SEWAGE DISPOSAL SYSTEM

HOWARD COUNTY HEALTH DEPARTMENT

SUBDIVISION Brighton Pines LOT 21 ROAD 13803 Lakeside Drive

Approved Septic System Plan

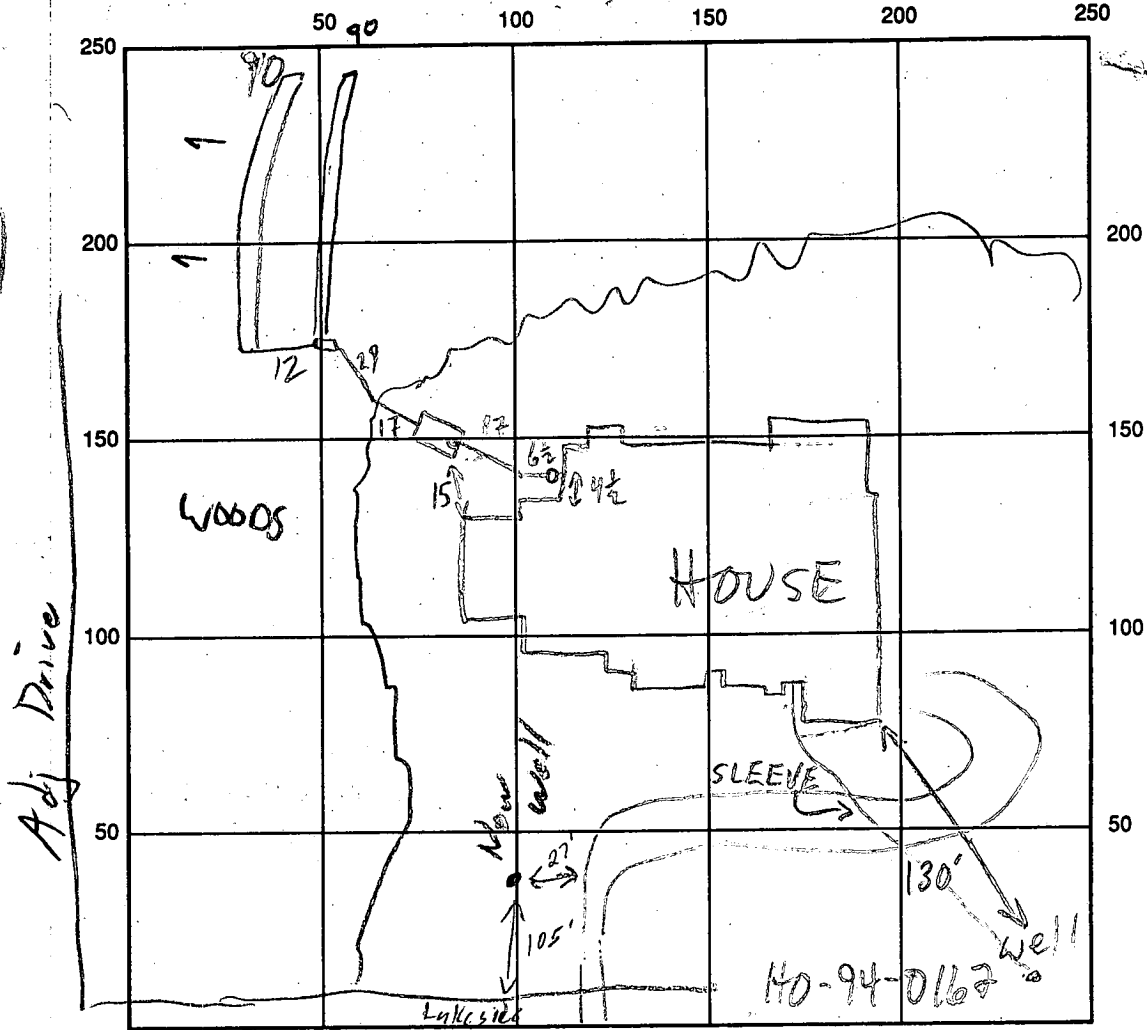
SEPTIC TANK LEVEL 1250 GAL-OK CLEANOUTS S.T. + INLINE - OK
 DISTRIBUTION BOX LEVEL OK - BAFFLE IN
 DRAIN FIELD/TITLE DEPTH 8/8 FT. TRENCH WIDTH 2 FT. INLET DEPTH 4/4 FT.
 EFFECTIVE GRAVEL DEPTH 4/4 FT. TOTAL LENGTH 2 @ 90 FT.
 NUMBER OF TRENCHES 2 ONE SIDEWALL/BOTTOM AREA 2 @ 360 SQ. FT.
 DRYWALL INSIDE DIAMETER FT. EFFECTIVE DEPTH BELOW INLET FT.

REMARKS: 10/29/98 WPI OK 4-5' B.G. 2-PC CAP OK (KH PLG. 857-0255)
10/29/98 OK TO STONE TRENCH @ D16 (2) (MR)
10/29/98 TRENCH 2 OK TO COVER, COVER ALL WORK
10/29/98 WPI OK 4-5' B.G. 2-PC CAP OK (KH PLG. 857-0255)
 DATE SYSTEM APPROVED 10/29/98 INSPECTOR [Signature]

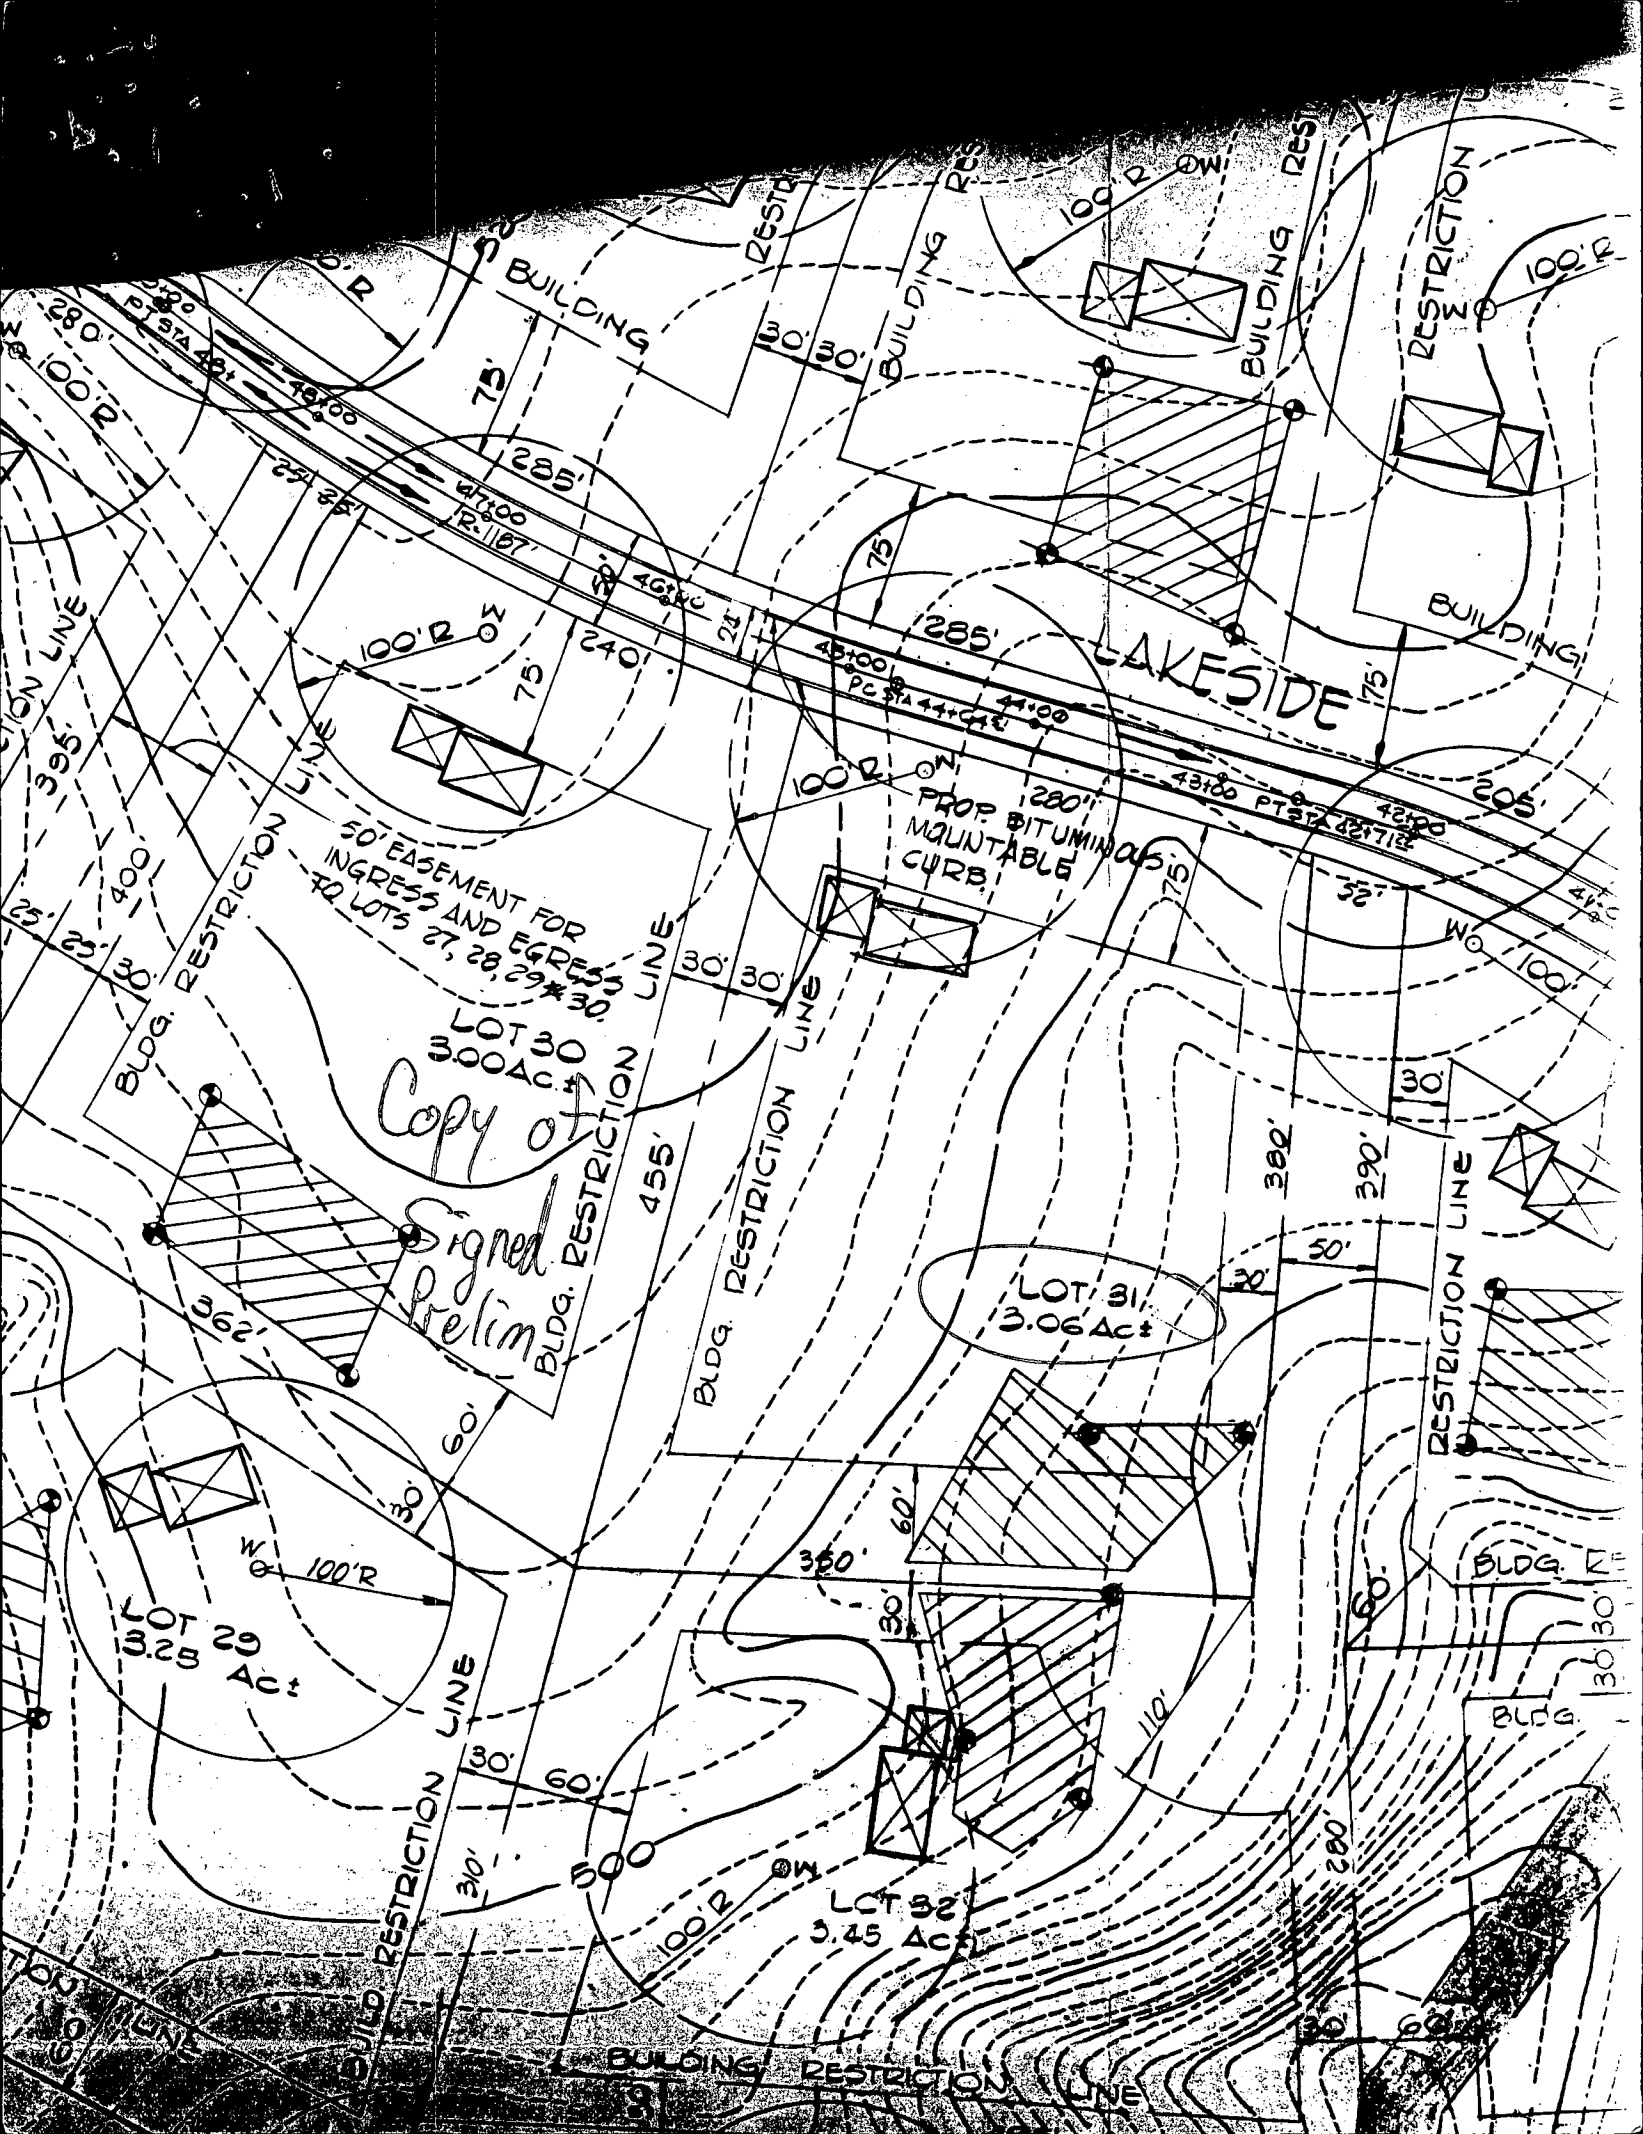
Change house type

modified house location
or as proposed. *(DS)*

REVISED 9/30/98 *(DS)*

By copy of this plan, the Health Dept.
accepts the modification to the septic area
